Well Name: CO 3 34 FEDERAL	Well Location: T25S / R32E / SEC 10 / NENW / 32.150076 / -103.66649	County or Parish/State: LEA / NM
Well Number: 627H	Type of Well: OIL WELL	Allottee or Tribe Name:
Lease Number: NMLC061936	Unit or CA Name: COTTON DRAW UNIT	Unit or CA Number: NMNM70928X
US Well Number: 3002554208	Operator: CHEVRON USA INCORPORATED

Type of Action: APD Change

Procedure Description: Chevron U.S.A. Inc. is proposing to sundry CO 3 34 FEDERAL 627H in Cotton Draw to revise the well names, C102s, 9-point plans and directional drilling plan. Please note that some of the changes below have already been approved by the BLM but due to NMOCD records these changes need to be explicitly called out and approved by the BLM again. Well Name Change Current BLM Name: CO 3 34 FEDERAL 627H o Current NMOCD Name: CO 3 34 FEDERAL 306H o New BLM/NMOCD Name: CO 3 34 FEDERAL 627H Note:(the current NMOCD name is being included to correct NMOCD records) • C102 Changes o Pool Code: Changing 96715 to 98270 o Pool Name: Changing WC-025 G-06 S253209L; Bone Spring to WC-025 G-08 S253216D; Upper Wolfcamp o Surface Hole Location: Changing the north call from 790' to 784' o Bottom Hole Location: Changing

ACREAGE DEDICATION PLATS

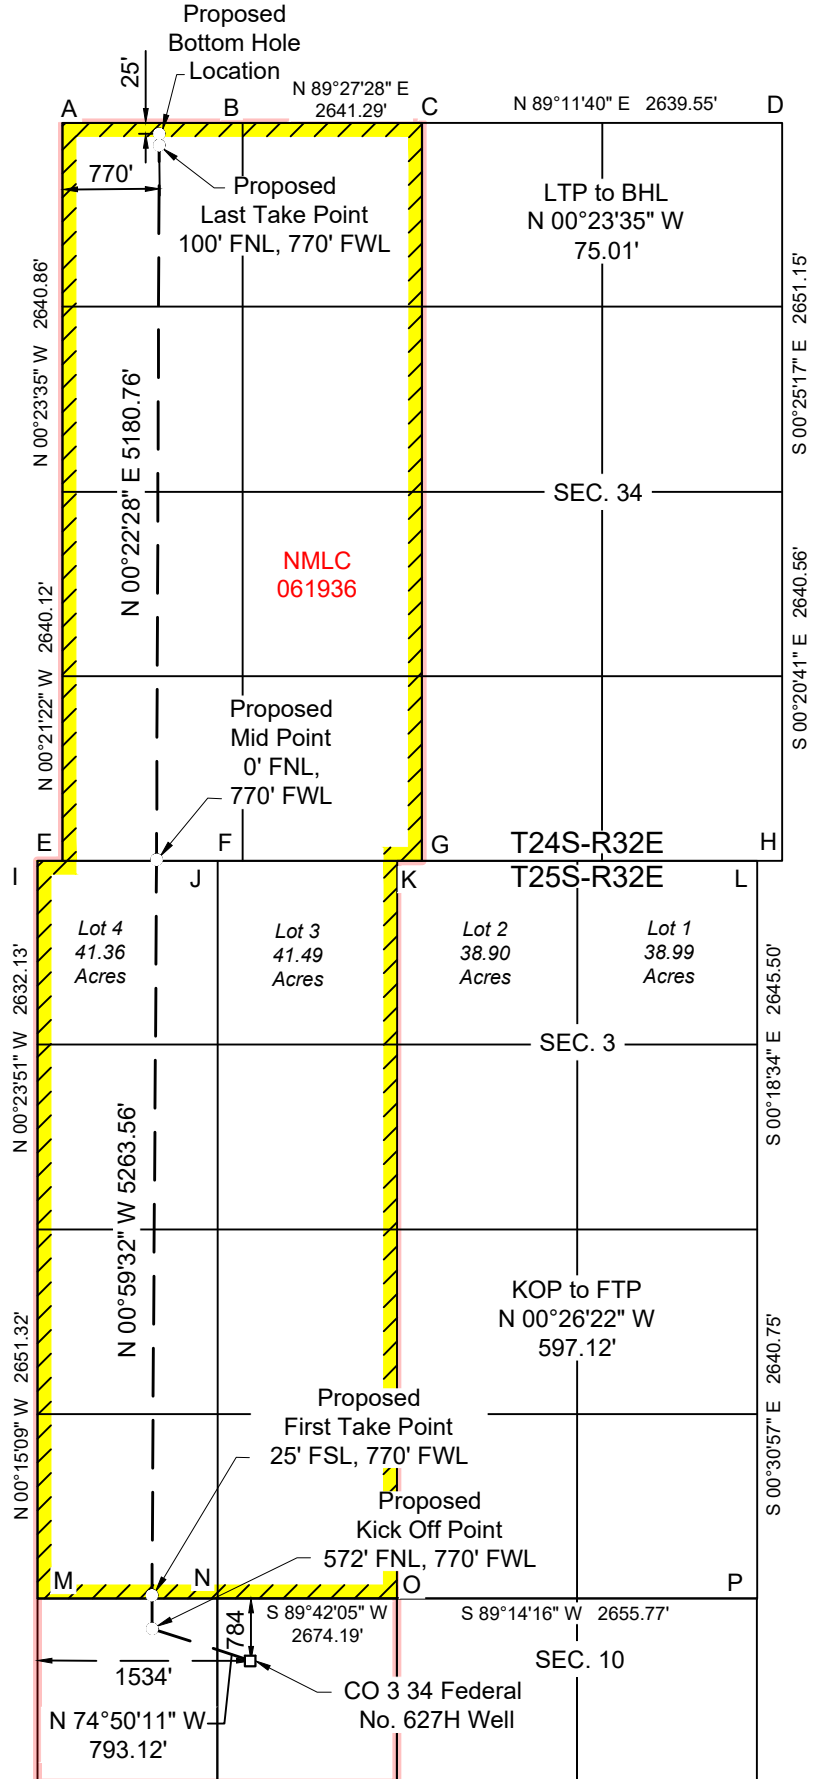
- **Surface Hole Location:** Changing the north call from 790' to 784'
 - **Bottom Hole Location:** Changing the west call from 1380' to 770'
 - **Dedicated Acreage:** Changing 639.37 to 642.85

- **Defining Well:** Changing 30-025-49783 to 30-025-53502
 - **Kick off Point:** Changing from 25' from the South and 1380' from the West of Section 3, T25S-R32E to 572' from the north and 770' from the west of Section 10, T25S-R32E

- **First Take Point:** Changing the west call from 1380' to 770'
 - **Last Take Point:** Changing the west call from 1380' to 770'
 - **Lease Number on Plat:** Corrected NMLC 19136 to NMLC 061936

Project: Lea County, NM (NAD27 NME)
 Site: CO Pad 627
 Well: CO 3 34 Federal No. 627H
 Wellbore: OH - 54208
 Design: Plan 3 R1
 Rig: Patterson 289

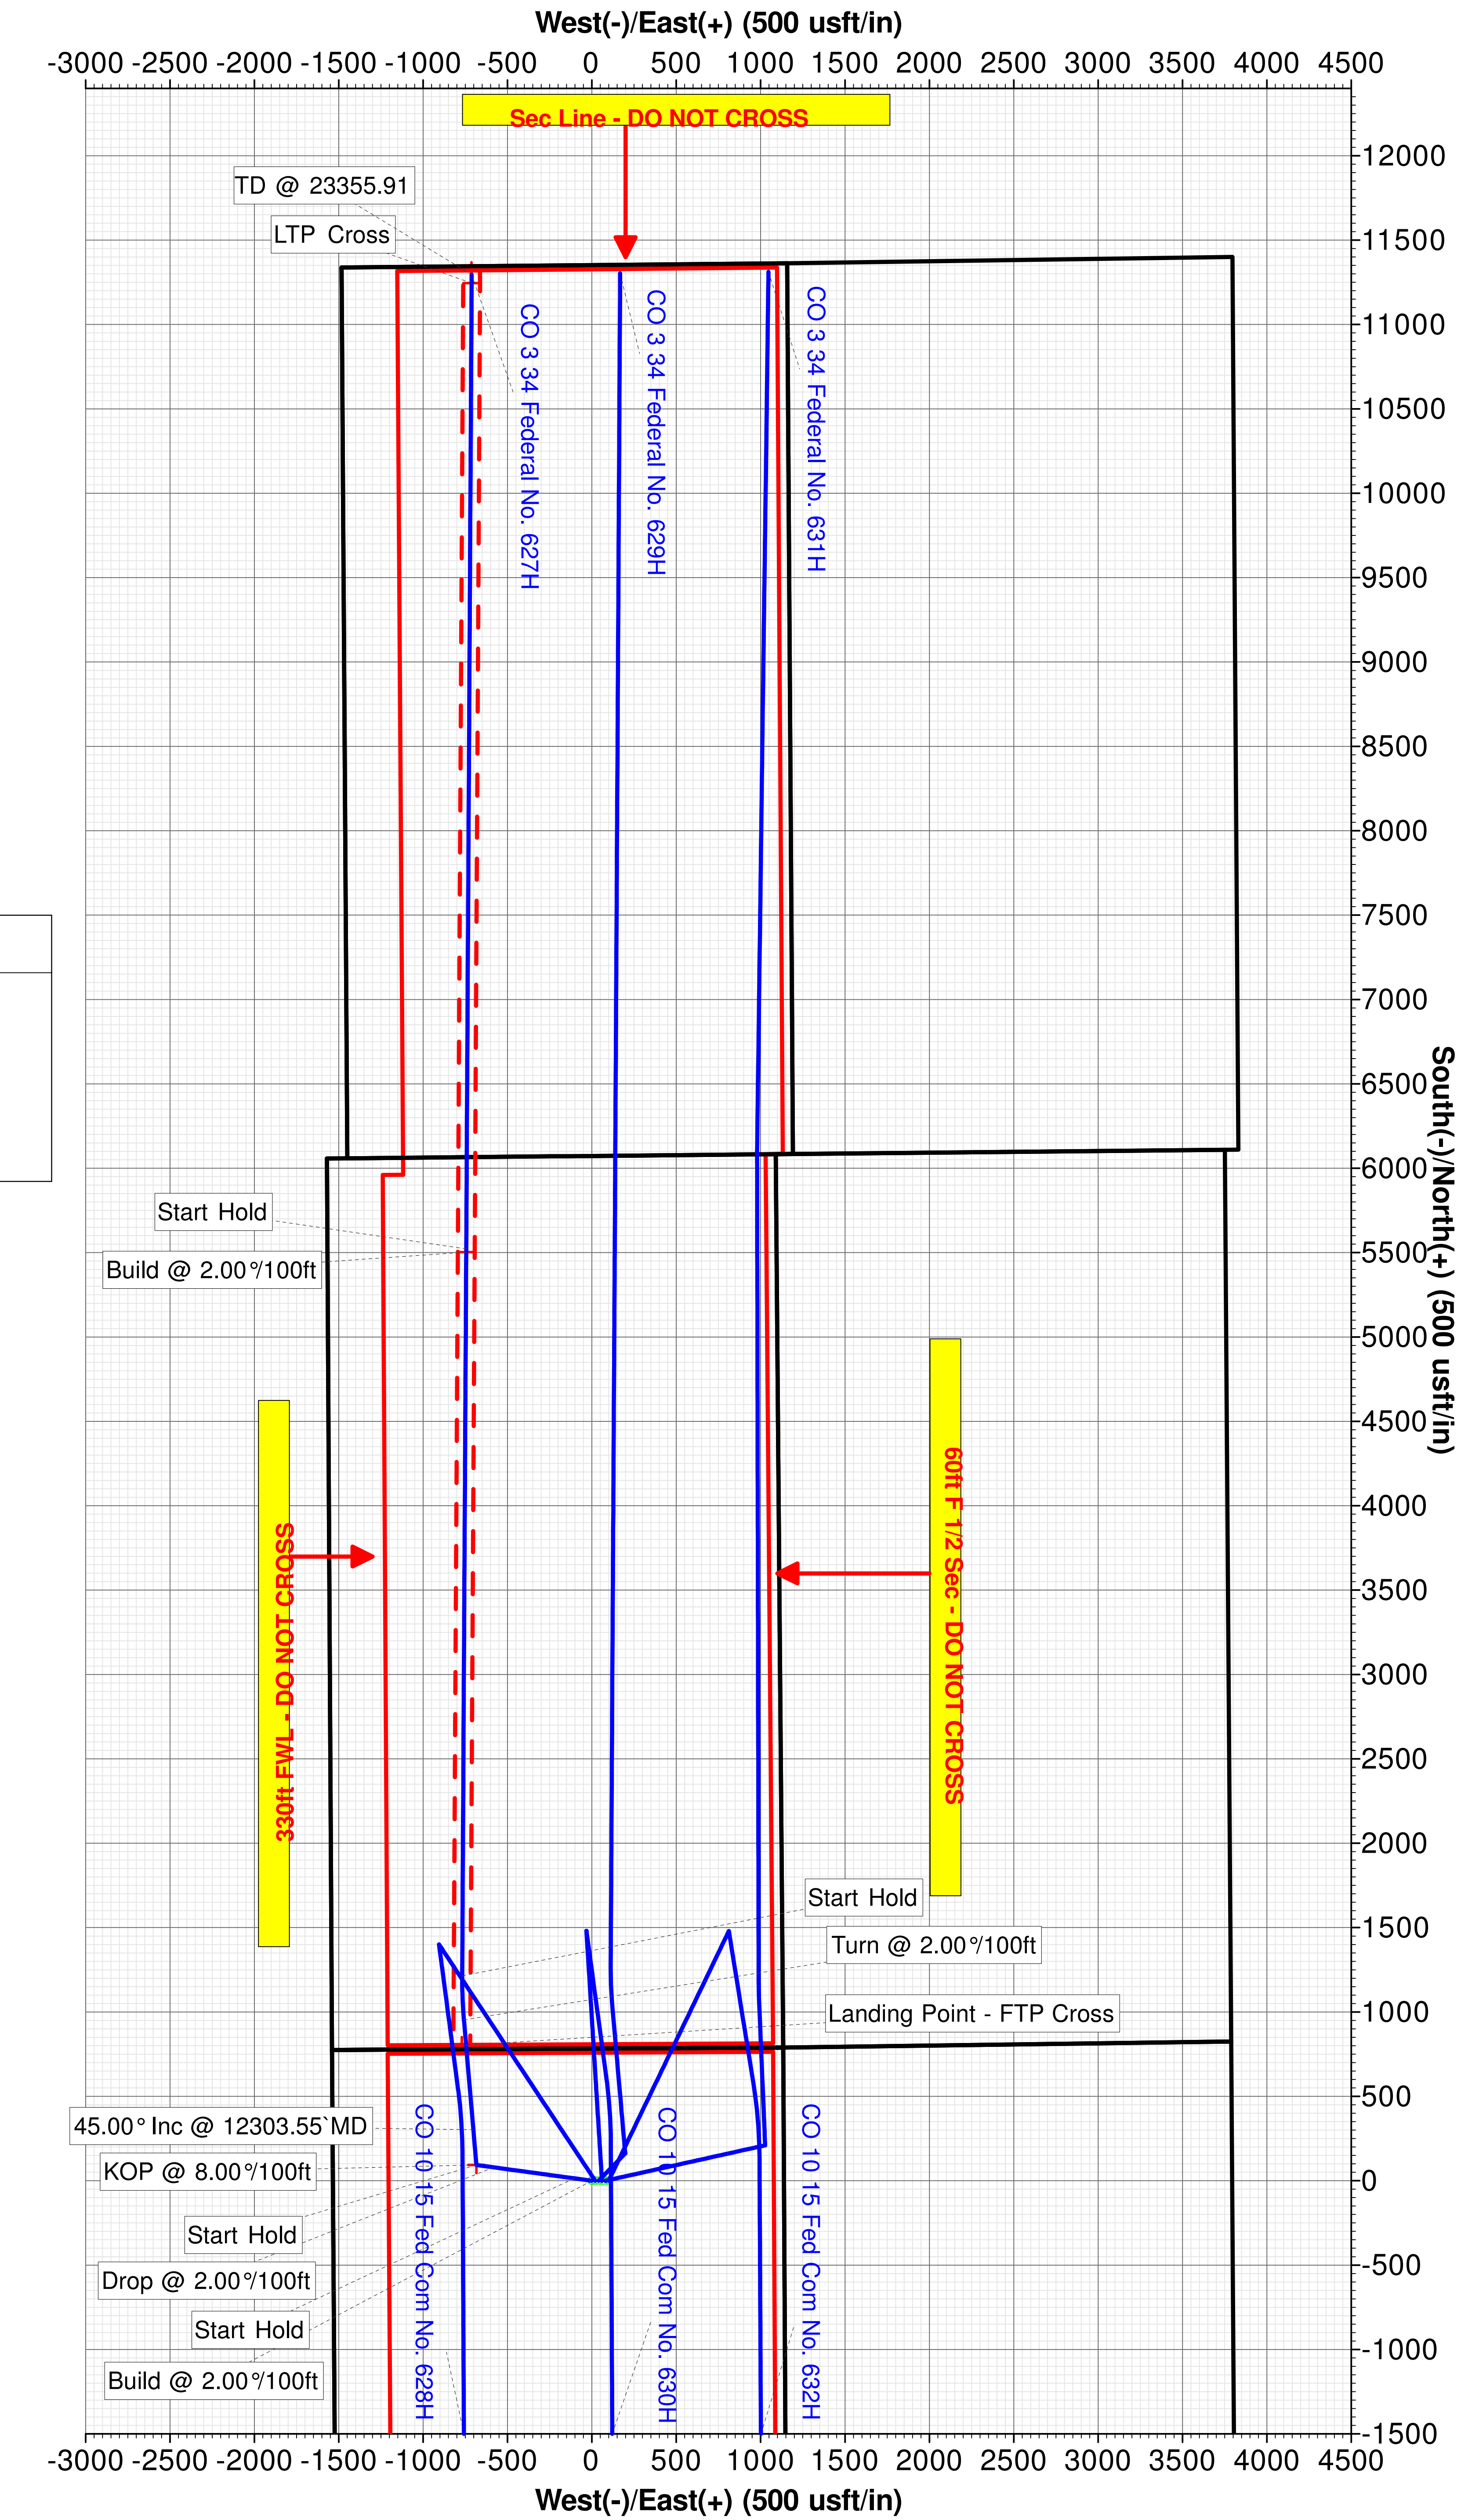
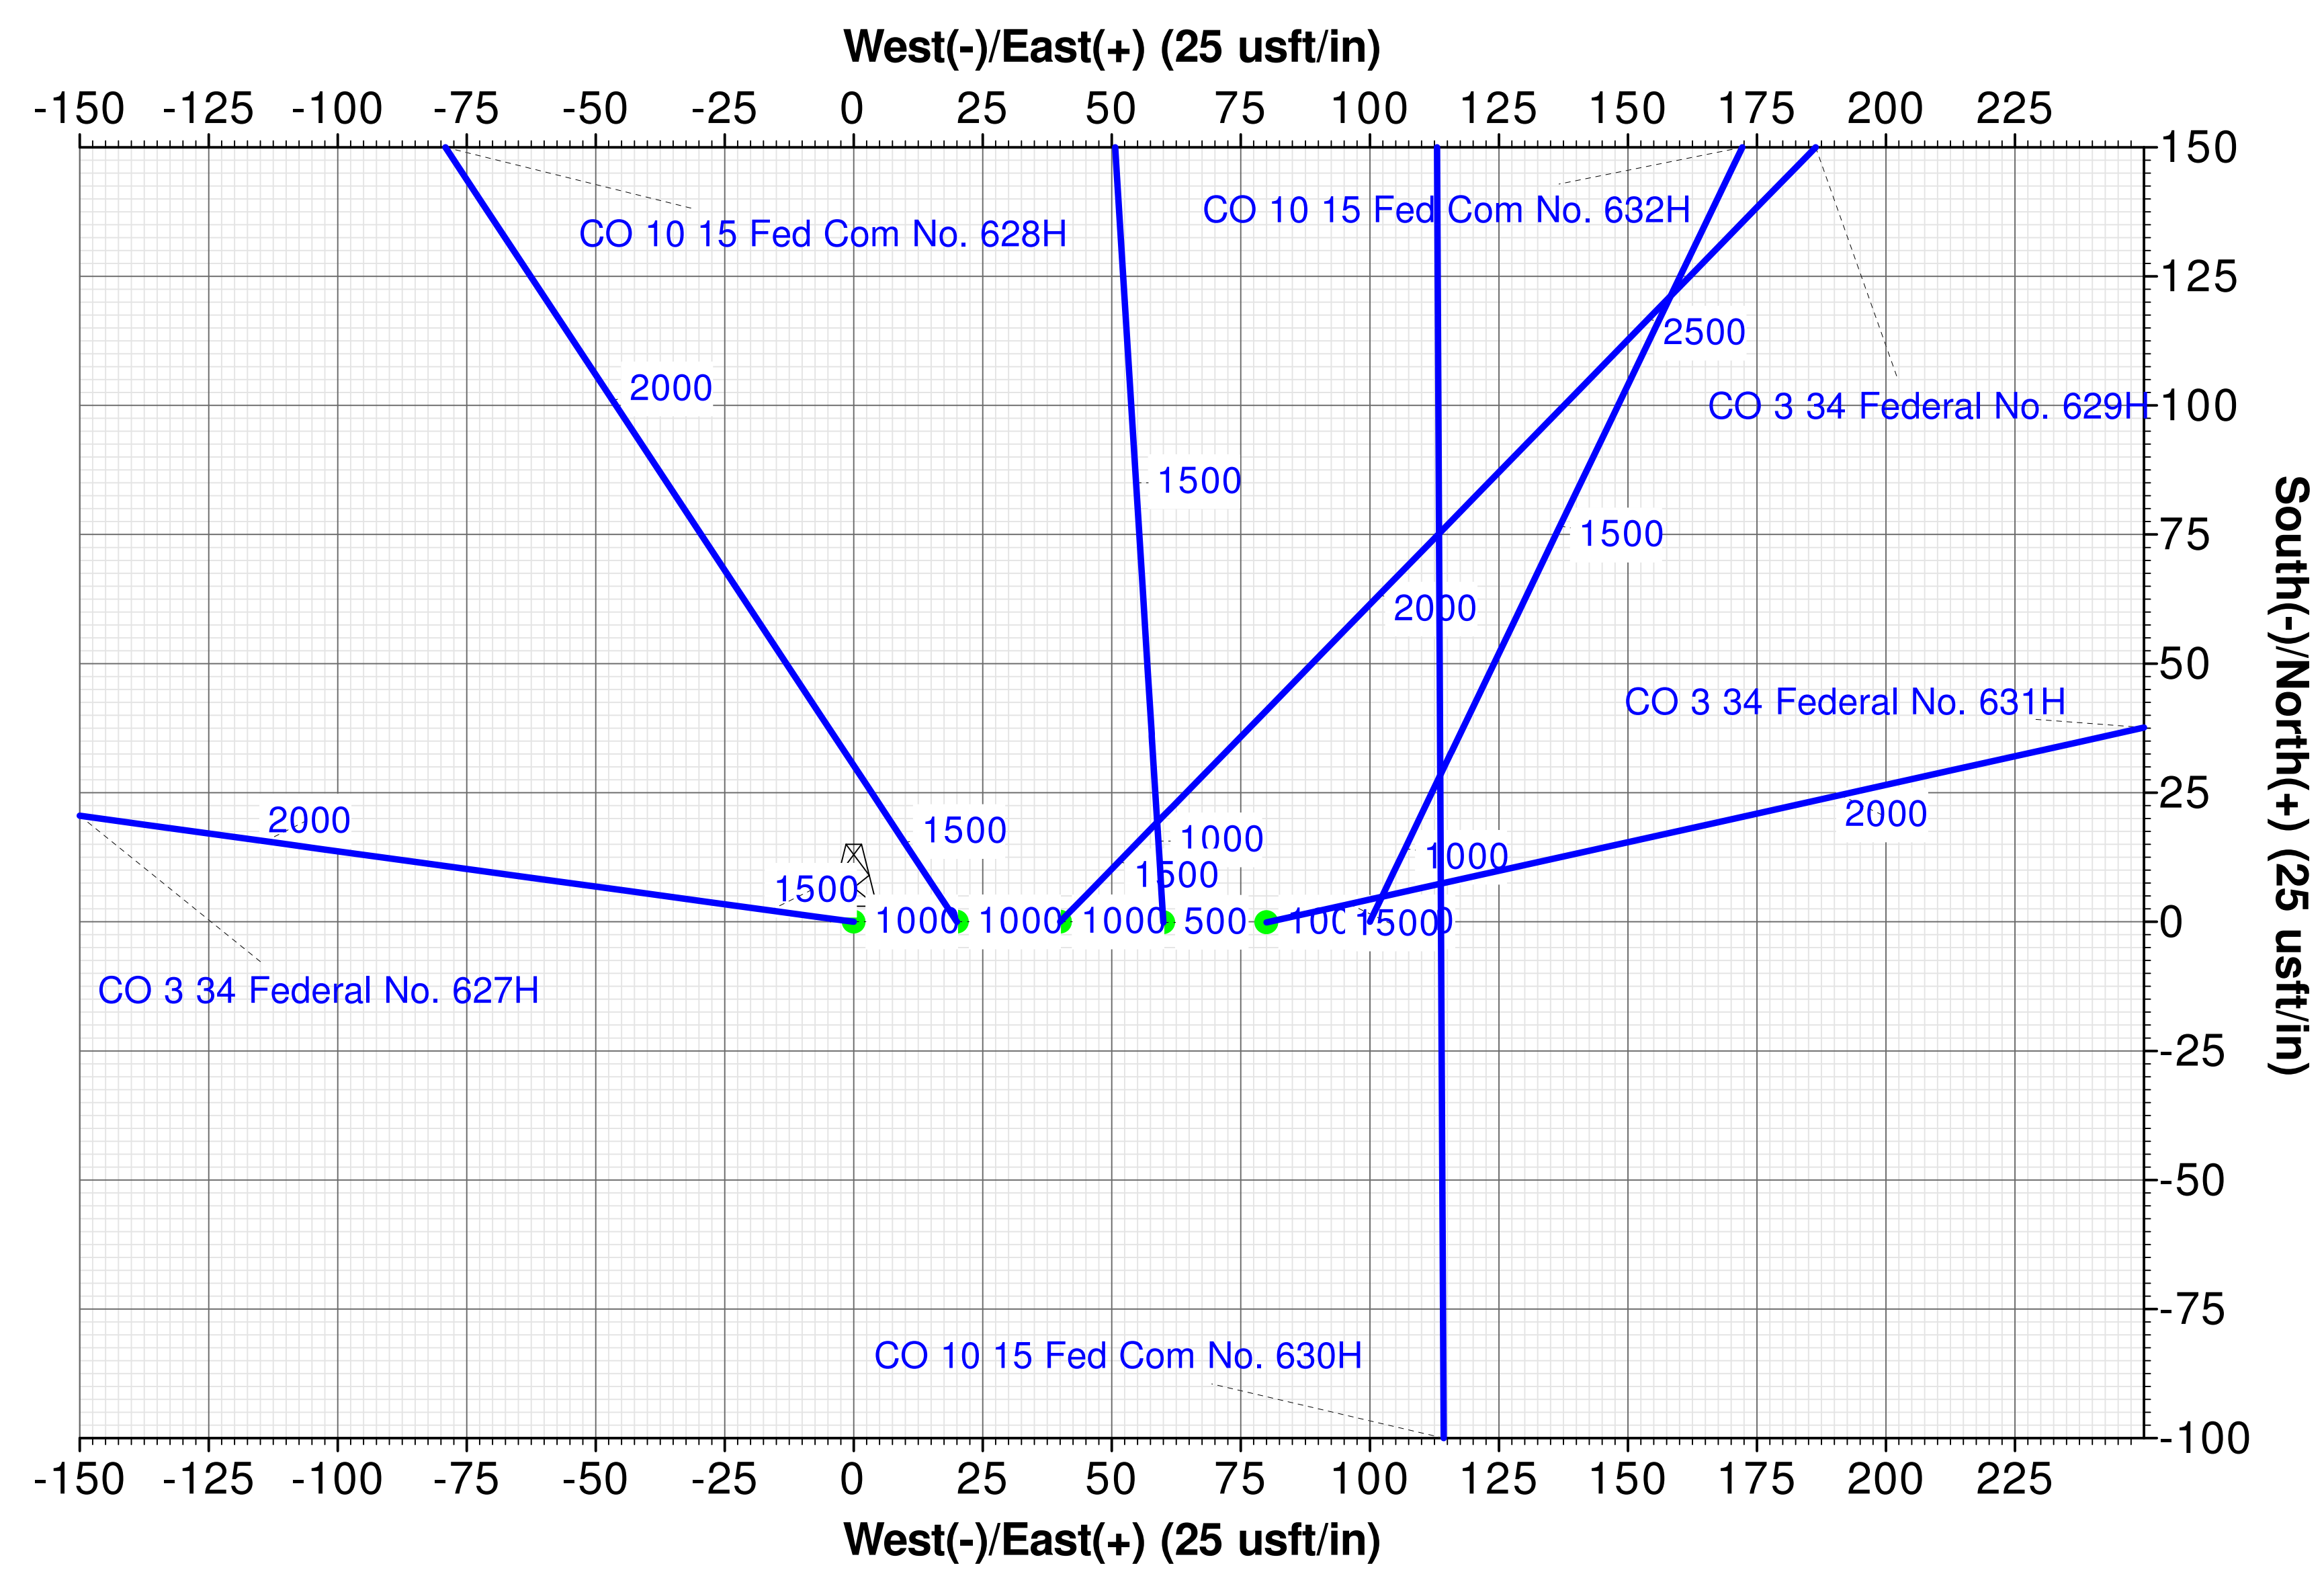
- **Updated Directional Drilling Plan**
